HISTORIC AND DESIGN REVIEW COMMISSION

July 06, 2018

HDRC CASE NO: 2018-207
ADDRESS: 410 N OLIVE ST
LEGAL DESCRIPTION: NCB 578 BLK D LOT 2
ZONING: RM-4. H
CITY COUNCIL DIST.: 2
DISTRICT: Dignowity Hill Historic District
APPLICANT: Jenny Hernandez
OWNER: Jason Beltran
TYPE OF WORK: Construction of a one story, single family residential structure
APPLICATION RECEIVED: June 20, 2018
60-DAY REVIEW: August 19, 2018
REQUEST:

The applicant is requesting a Certificate of Appropriateness for approval to construct a one story, single family residential structure on the vacant lot at 410 N Olive to feature approximately 1,980 square feet.

FRONT ELEVATION

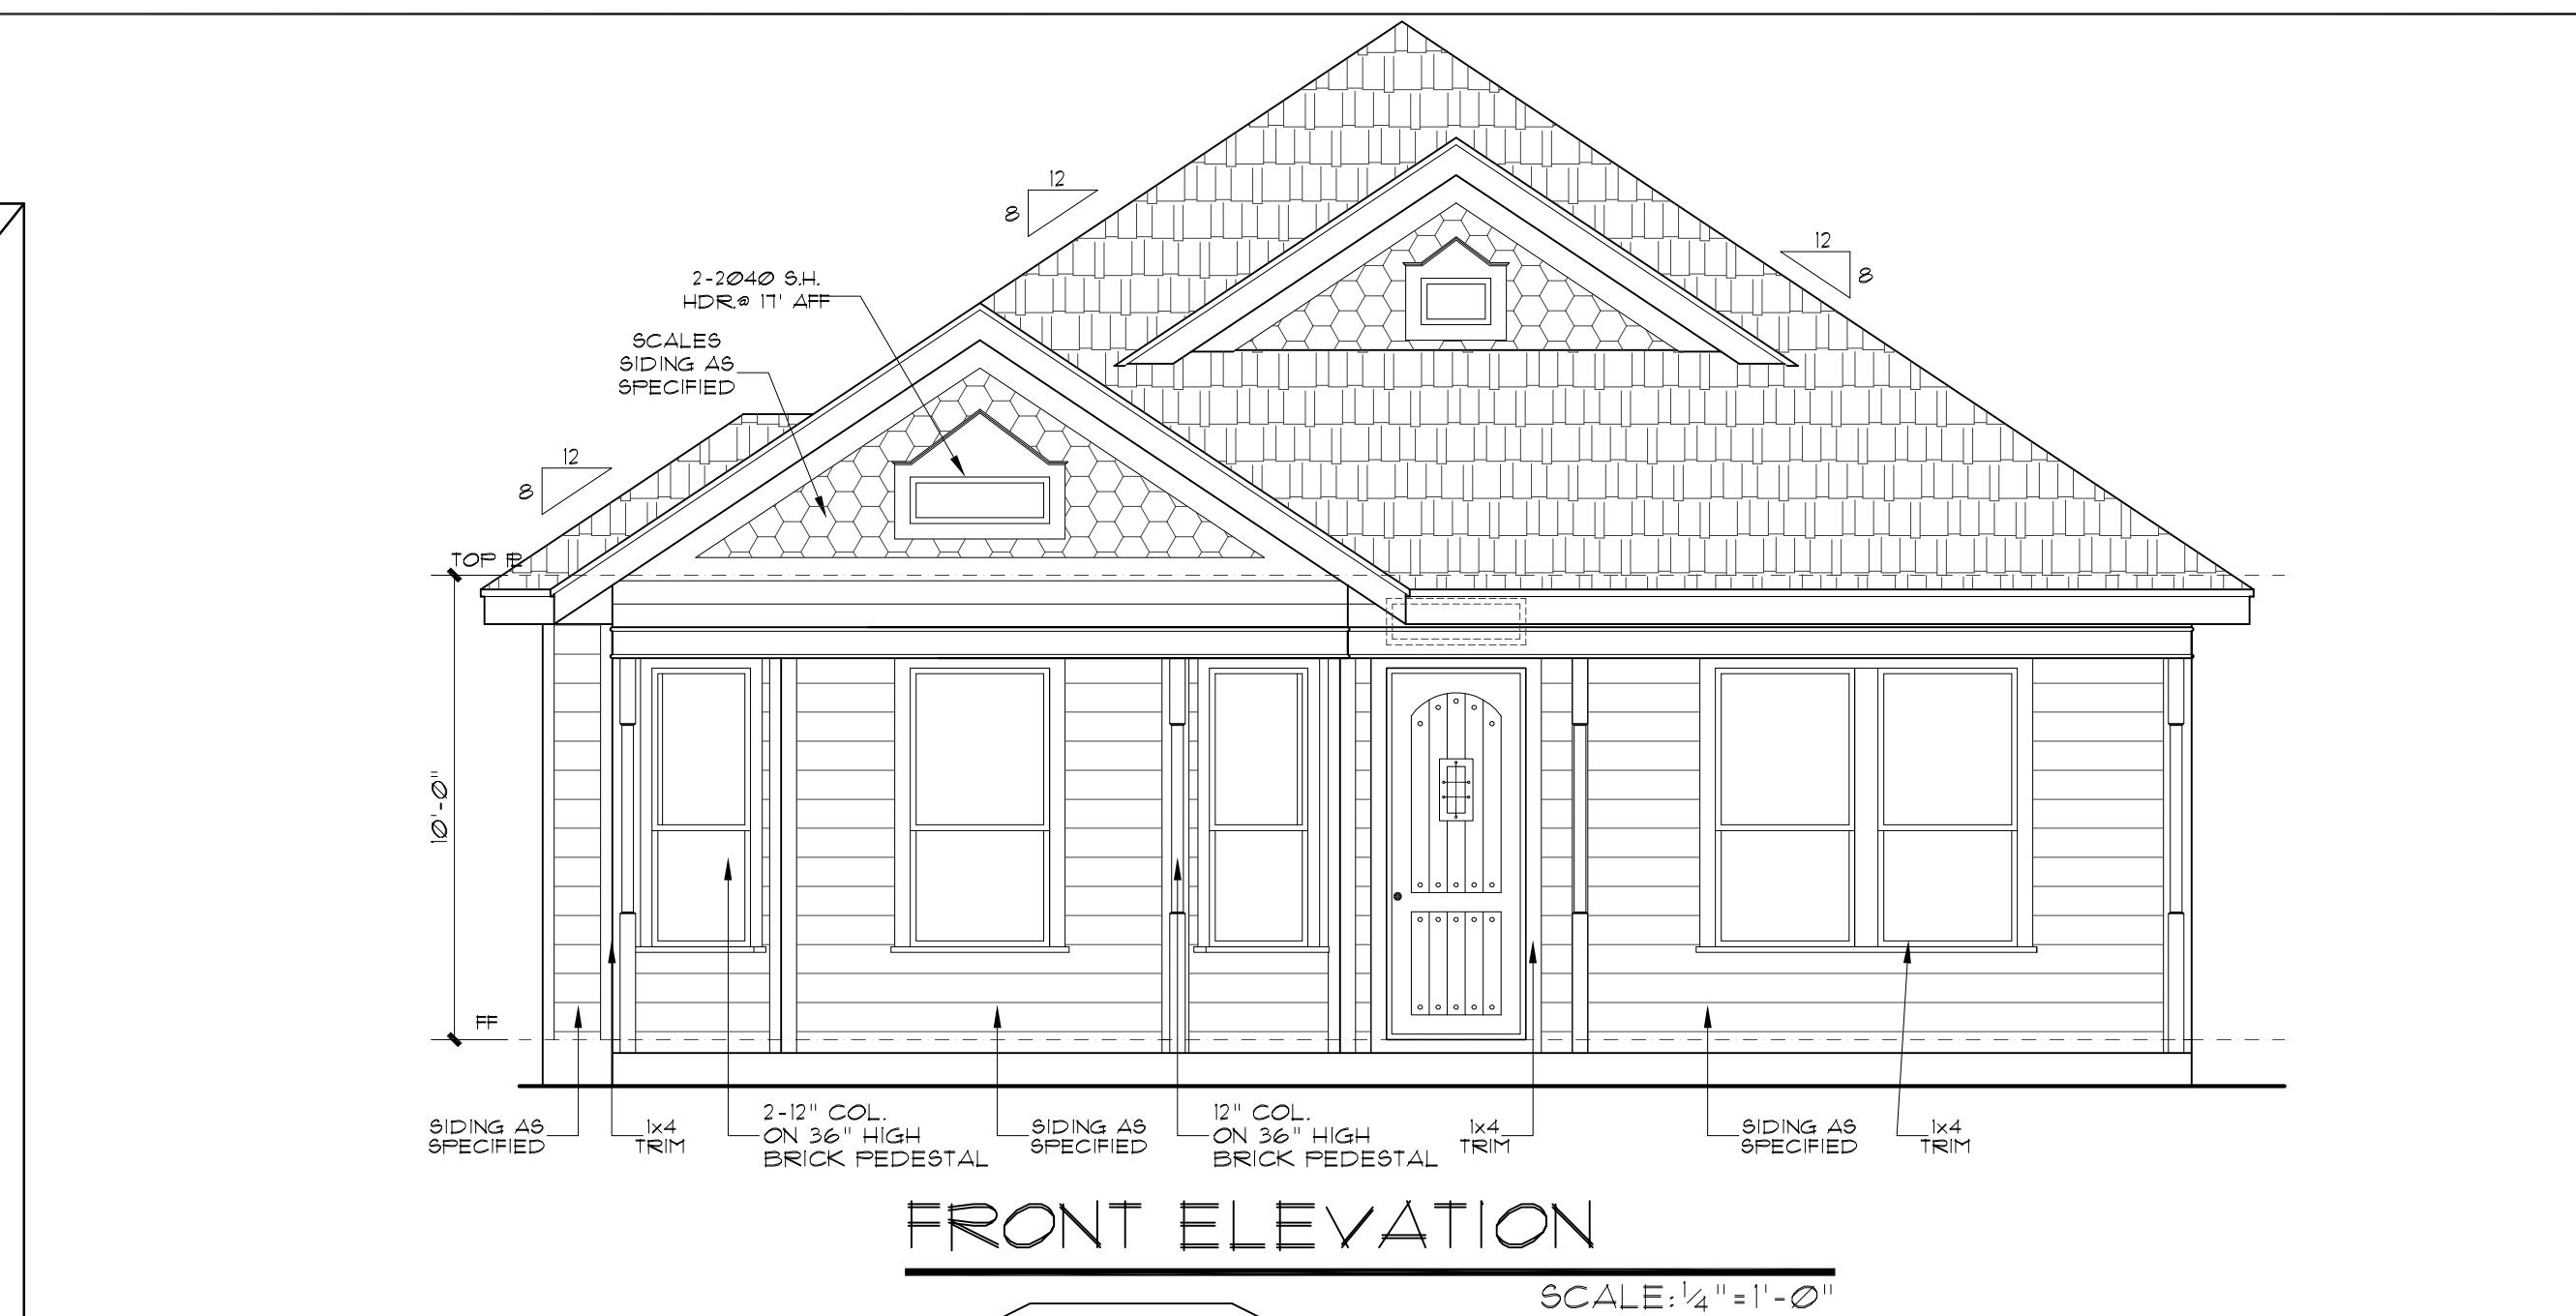
- iii. That the primary wall of the structure should be shifted toward the rear to produce a true "L-plan", rather than feature a window bay that shares a wall plane with both the porch and front façade of the house. **The applicant has met this stipulation by increasing the front porch depth to six (6) feet.**

- h. WINDOW & DOOR OPENINGS – Per the Guidelines for New Construction 2.C.i., window and door openings with similar proportions of wall to window space as typical with nearby historic facades should be incorporated into new construction. The applicant has proposed window openings that feature sizes and locations comparable to those found historically in the district. Double windows should feature a mullion of at least six inches between openings. A transom window should be featured above the front entrance door.

- i. WINDOW BAY (Fenestration) – The applicant has proposed a window bay to feature a total of three windows, with one window centered under the gable. This is appropriate.

Staff recommends approval based on findings a through m with the following stipulations:

- i. That stipulations regarding materials be adhered to as noted in finding j.
- ii. That stipulations regarding the proposed aluminum clad wood windows be adhered to as noted in finding k.
